40 - 120 H.P. Erratic Tachometer with Thunderbolt Ignition

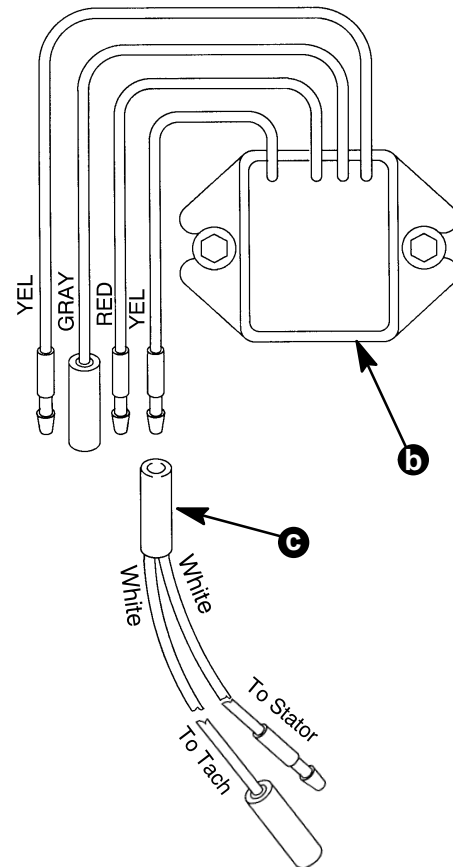
Several brands of tachometers have been found to read erratic with the rectifier/regulator (a) & (b) pictured below.

To correct this condition the tachometer lead must be connected to the Yellow rectifier/regulator lead that does not have continuity to the Gray rectifier/regulator lead. Test as follows to determine which Yellow lead to use:

1. Disconnect battery and all rectifier/regulator leads.
2. Using an ohm meter (RX1) test for continuity between each Yellow rectifier lead and Gray rectifier lead.
3. Connect the tachometer to the Yellow rectifier lead that does not have continuity to the Gray rectifier lead.

Order Adaptor Harness Kit (c) P/N 84-11149A12 for the bullet style rectifier/regulator (b) pictured below.
